File: 38050-03/ Nicola Valley Aggregates

To: Vanessa Dunae, Senior Negotiations Lead, Regional Operations
Ministry of Energy, Mines and Petroleum Resources
Via email to Vanessa.Dunae@gov.bc.ca

From: David Thomson, P.Geo., Regional Hydrogeologist
Ministry of Forests, Lands, Natural Resource Operations & Rural Development
South Area Groundwater Science, Vernon, BC.
David.Thomson@gov.bc.ca

Re: Review of Active Earth Engineering Ltd (Active Earth) Reports: “Revised Hydrogeological Study” and “Preliminary Hydrogeological Study Response”

Figure 1: Water wells in the vicinity of the site, accessed from GWELLS on September 14, 2020

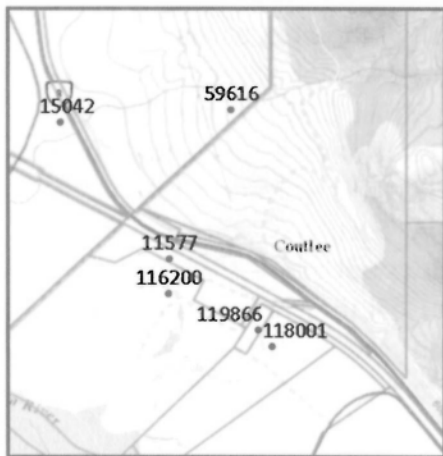
The bolding above indicates the key missing information in the Reports. The apparent down slope users have not been field-verified, as recommended above, so the degree of hydrogeological study required is not apparent. Figure 1 from FLNRORD's earlier 2020 response, and reproduced below, indicates existing water wells of interest that are available to review from a desktop analysis as well as a field visit. In the absence of this knowledge it is difficult to design appropriate site-specific mitigative measures. More specifically, it is best practice for aggregate operators to design site-specific measures in regards to groundwater protection, then additional site-specific information about groundwater is required relative to these downslope users.

With respect to the downgradient private wells (shown in Figure 1 but not necessarily limited to those), FLNRORD restate their previous comment:

Figure 1: Water wells in the vicinity of the site, accessed from GWELLS on September 14, 2020

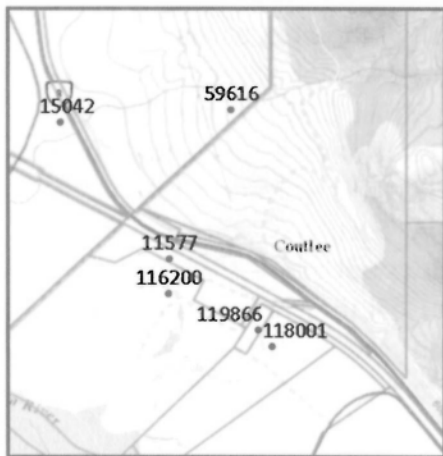
The bolding above indicates the key missing information in the Reports. The apparent down slope users have not been field-verified, as recommended above, so the degree of hydrogeological study required is not apparent. Figure 1 from FLNRORD's earlier 2020 response, and reproduced below, indicates existing water wells of interest that are available to review from a desktop analysis as well as a field visit. In the absence of this knowledge it is difficult to design appropriate site-specific mitigative measures. More specifically, it is best practice for aggregate operators to design site-specific measures in regards to groundwater protection, then additional site-specific information about groundwater is required relative to these downslope users.

With respect to the downgradient private wells (shown in Figure 1 but not necessarily limited to those), FLNRORD restate their previous comment:

ACTIVE EARTH ENGINEERING LTD			
CLIENT NAME: NICOLA VALLEY AGGREGATES		PROJECT LOCATION: MERRITT, BC	
SITE PLAN (CONTOUR & AQUIFER MAP) 701 HIGHWAY 8			
DWN BY: EB/GM	DWG NAME: -2	DATE: 2019-04-05	
CHK'D: DK	PLOT:	CADFILE: 1887	FIGURE 2

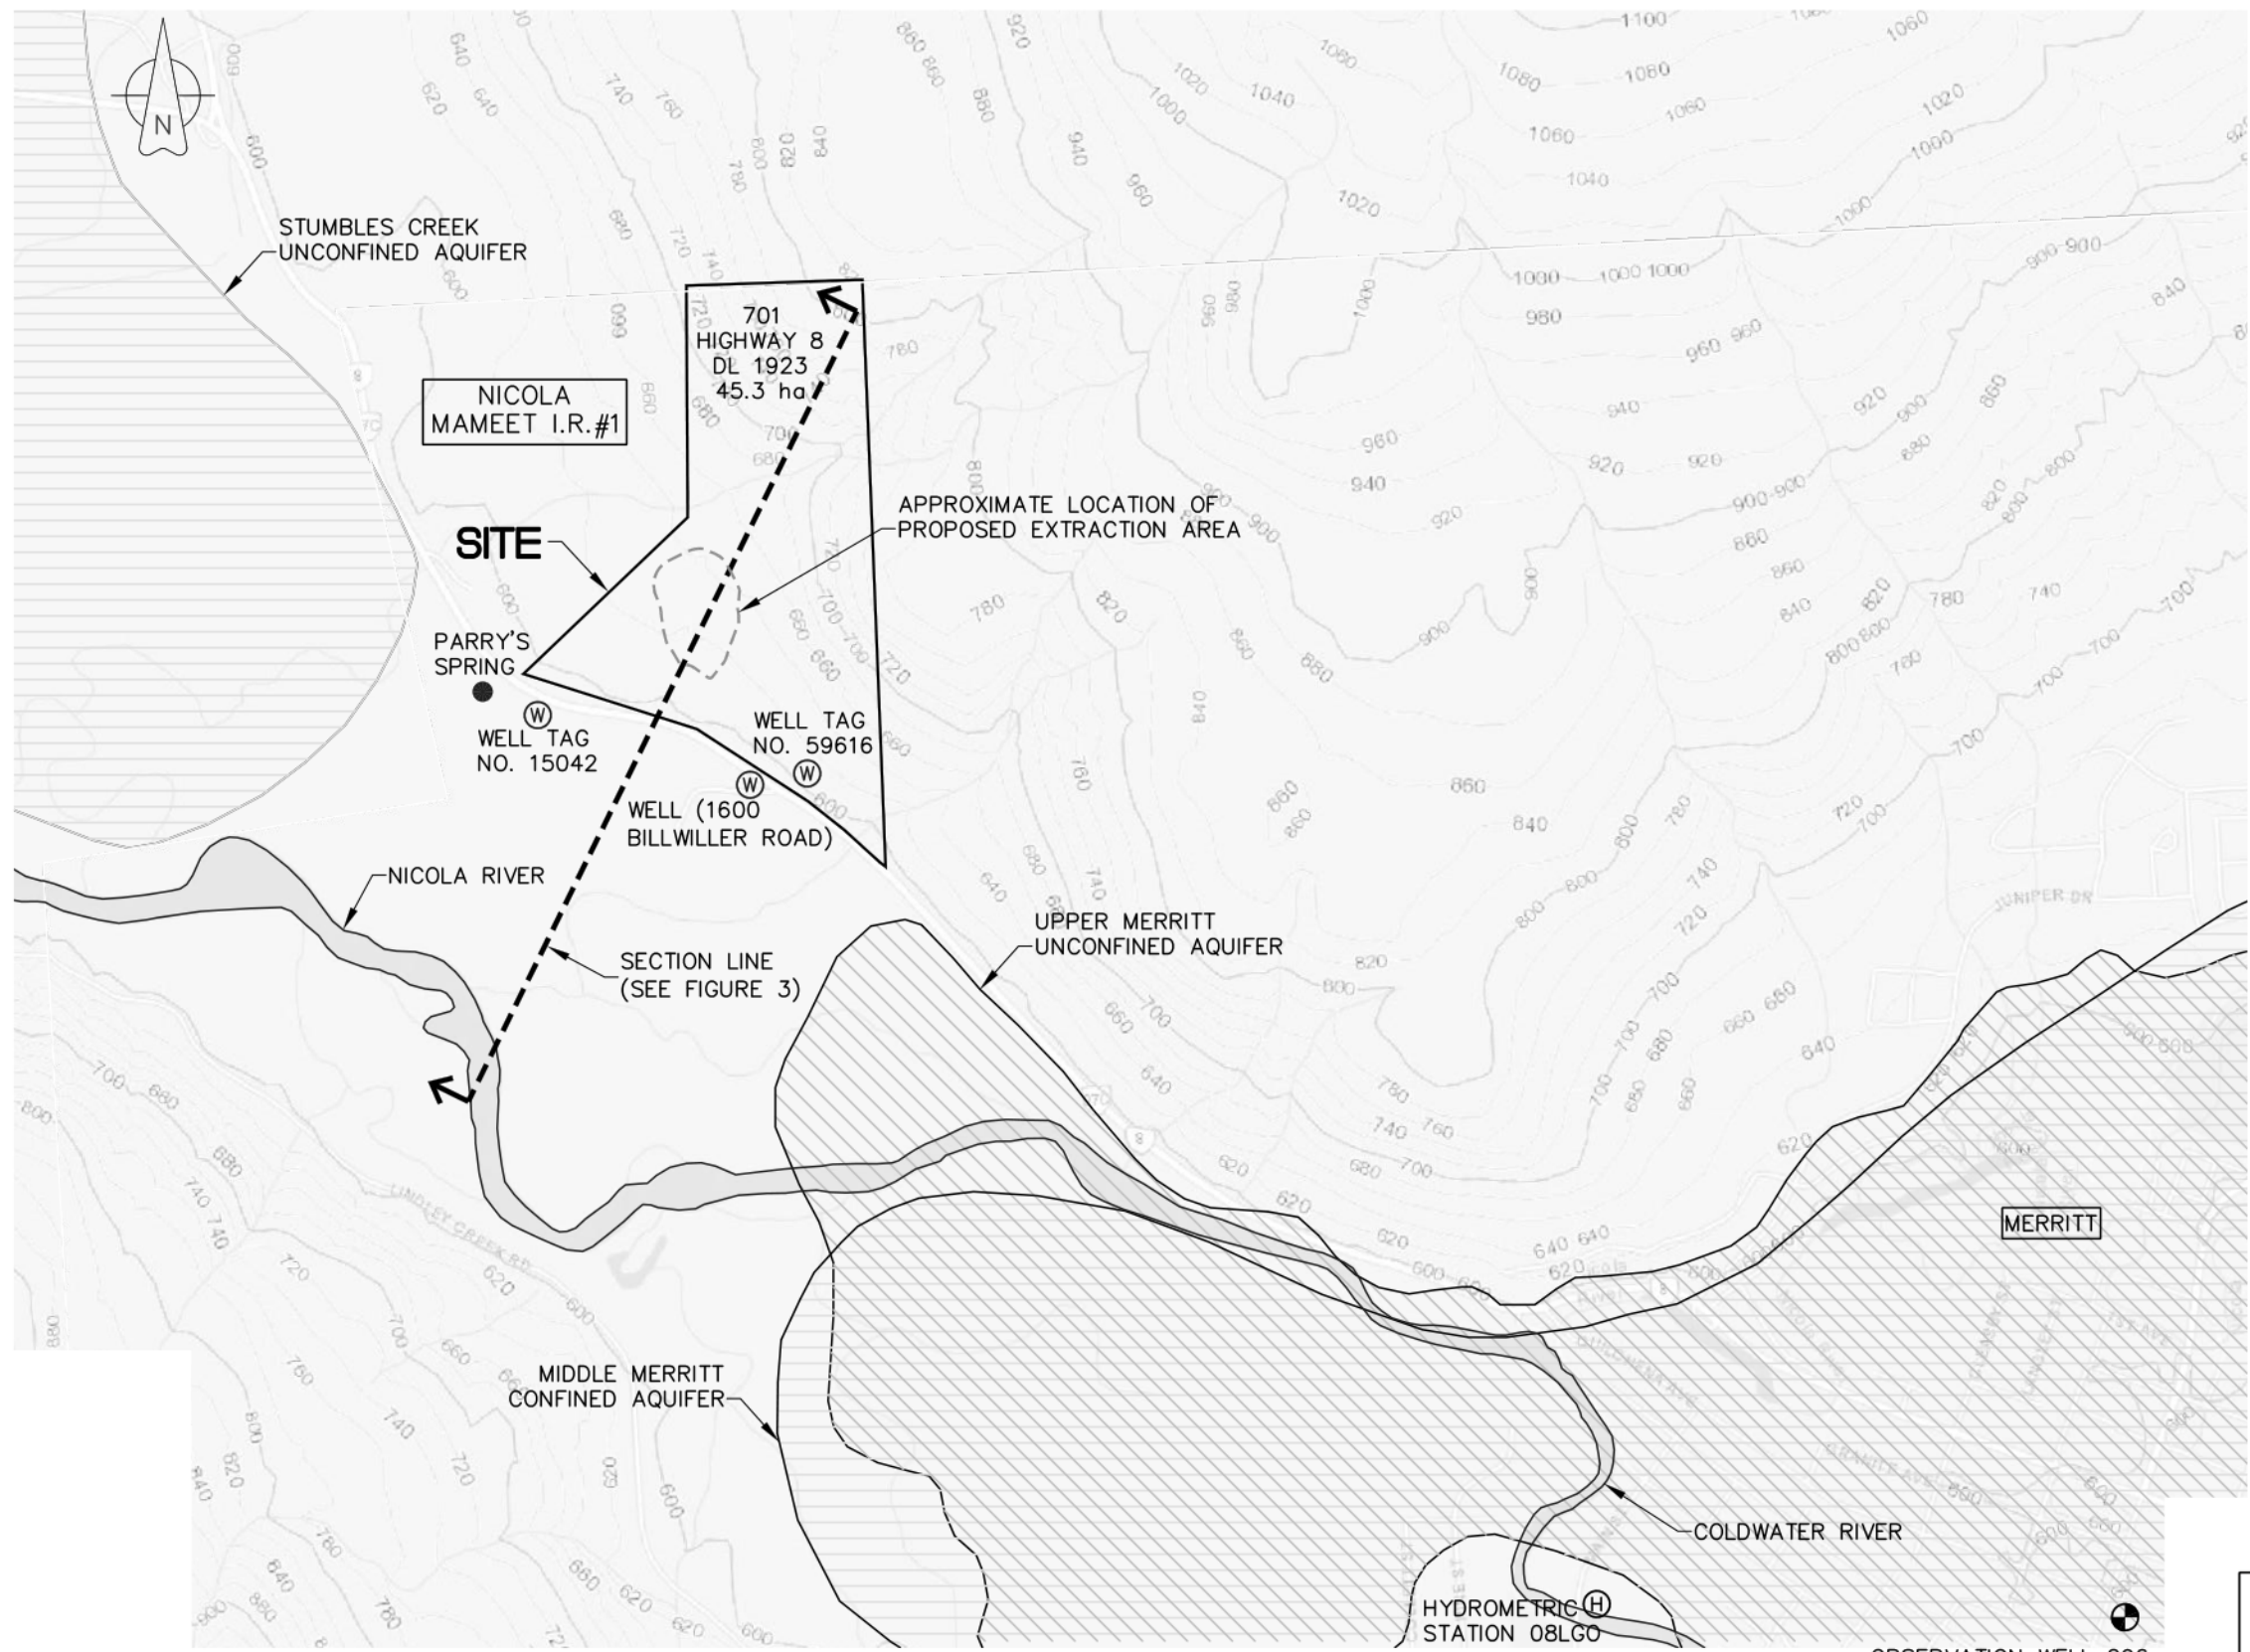
It is important to note first that while Figure 2 (Active Earth, 2019) has correctly identified Aquifer 74 as unconfined, the shading does not match the legend. This could lead the reader to believe there is not an unconfined aquifer on the other side of the proposed development. This

- FLNRORD noted that WTN 11577 is not present in the report. Please note that Figure 2 shows the most relevant wells as a result of ground truthing. It is common knowledge that old wells are not plotted correctly simply because they were located by legal description. We are aware that groundwater levels are shallower in the valley below Highway 8

FIGURE 3

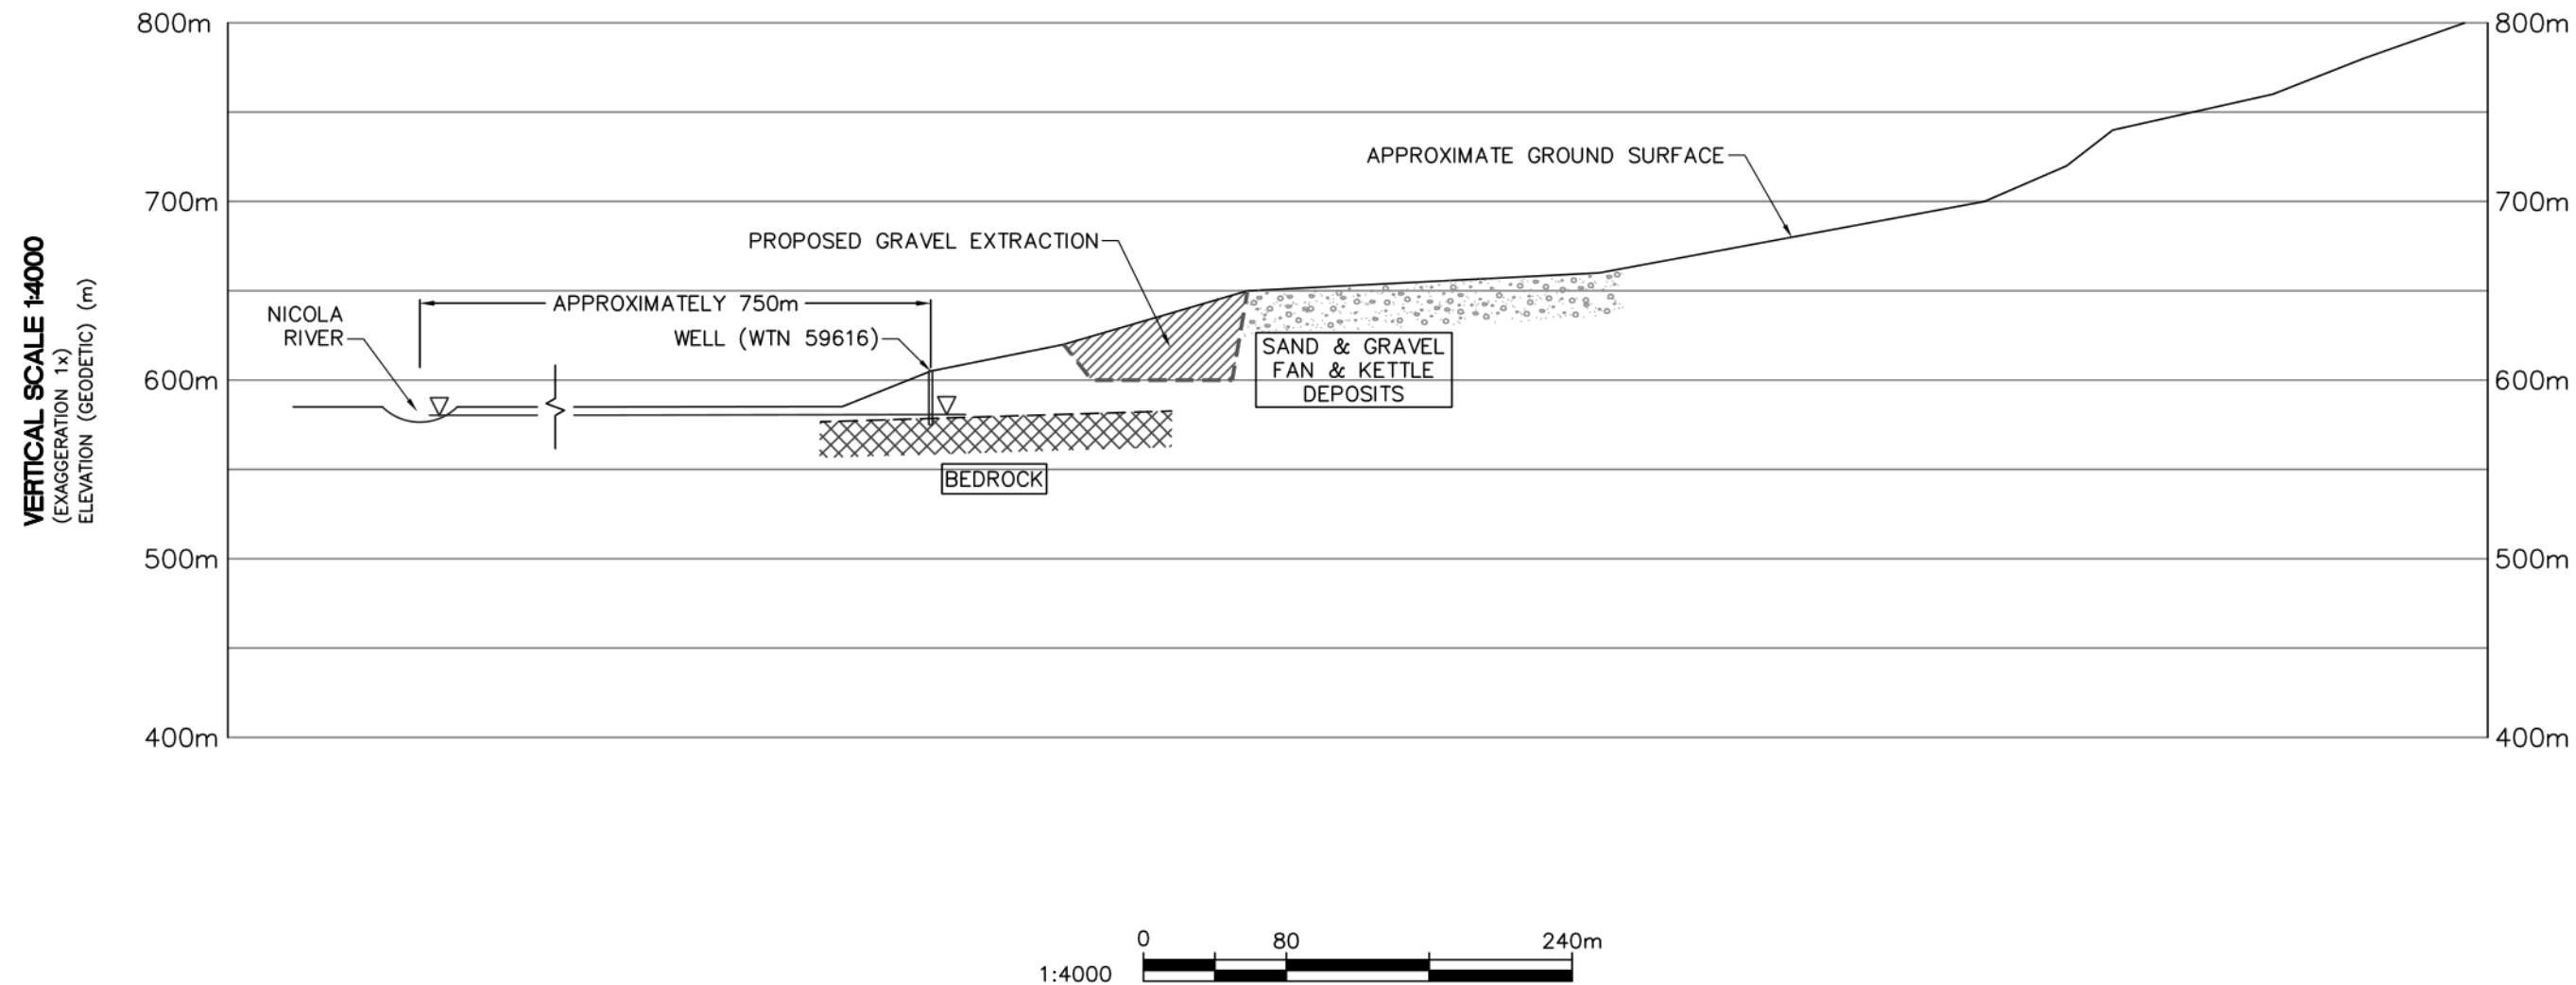
- b. The Conceptual Hydrogeological Section (Figure 3) shows shallow dipping bedrock and an assumed depth to bedrock beneath the proposed gravel pit. This has not been proven at this location and should be established by drilling and installing a monitoring well at the quarry.*

Figure 1: Water wells in the vicinity of the site, accessed from GWELLS on September 14, 2020

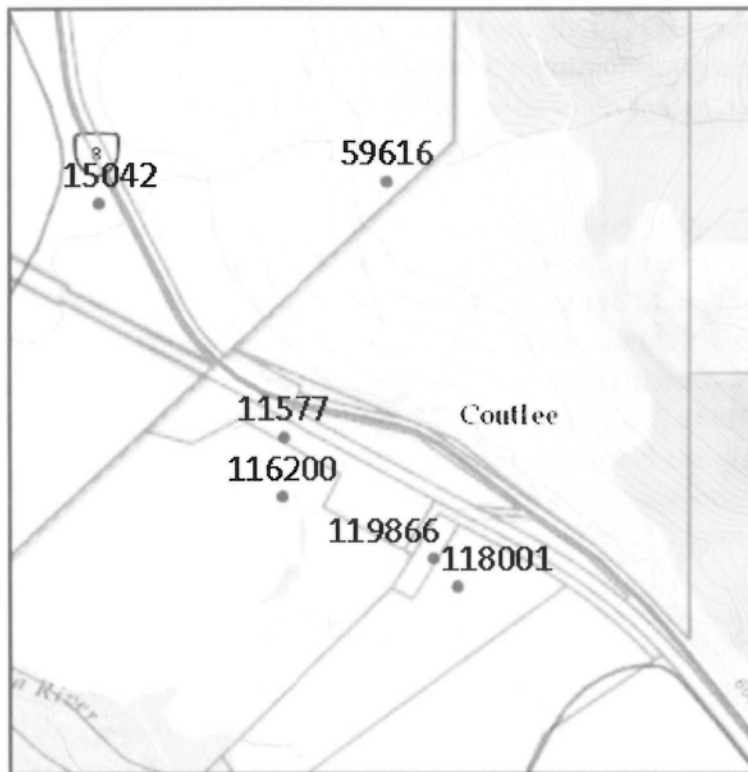
When accessed September 14, 2020, the GWELLS database showed 4 registered wells south of the site as shown in the screenshot below (Figure 1). Figure 2 (Active Earth, 2019) shows only three wells to be considered as part of the review; WTN 59616 is shown to exist south of the property, but the GWELLS database (accessed September 14, 2020) shows it to be present immediately west of the property. This well record is assigned to Aquifer 725, which is present approximately 10 km west of the site. WTN 15042 is shown in Active Earth's Figure 2 to be immediately south of the southwest property boundary, in contrast to online mapping that places it to the north west.

WTN 11577 is not present in Active Earth's report, but if located correctly in online mapping indicates groundwater at eight feet below the ground surface. This and other well information noted above needs to be reconciled and incorporated into a more detailed hydrogeological report, and should better inform a revised subsurface cross-section.

Figure 1: Water wells in the vicinity of the site, accessed from GWELLS on September 14, 2020

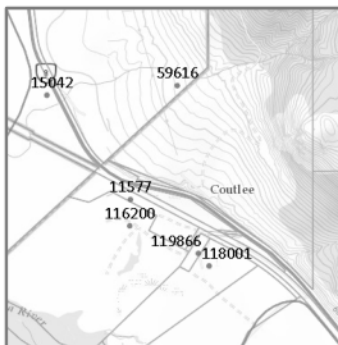
The bolding above indicates the key missing information in the Reports. The apparent down slope users have not been field-verified, as recommended above, so the degree of hydrogeological study required is not apparent. Figure 1 from FLNRORD's earlier 2020 response, and reproduced below, indicates existing water wells of interest that are available to review from a desktop analysis as well as a field visit. In the absence of this knowledge it is difficult to design appropriate site-specific mitigative measures. More specifically, it is best practice for aggregate operators to design site-specific measures in regards to groundwater protection, then additional site-specific information about groundwater is required relative to these downslope users.

With respect to the downgradient private wells (shown in Figure 1 but not necessarily limited to those), FLNRORD restate their previous comment:

Figure 1: Water wells in the vicinity of the site, accessed from GWELLS on September 14, 2020

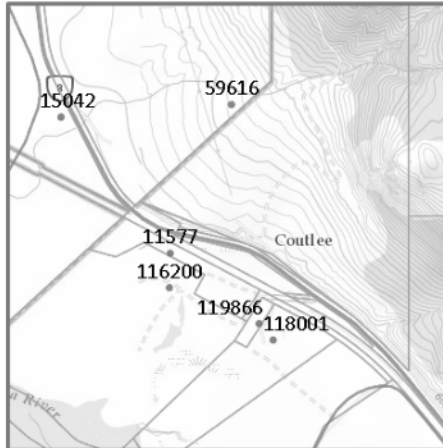
The bolding indicates the key missing information. The apparent down slope users have not been field-verified, so the degree of hydrogeological study required is not apparent. Figure 1 from FLNRORD's response earlier, and reproduced below, indicates existing water wells of interest that are available to review from a desktop analysis as well as a field visit. In the absence of this knowledge it is difficult to design appropriate site-specific mitigative measures. More specifically, it is best practice for aggregate operators to design site-specific measures in regards to groundwater protection, then additional site-specific information about groundwater is required relative to these downslope users.

With respect to the downgradient private wells (shown in Figure 1 but not necessarily limited to those), FLNRORD restate their previous comment:
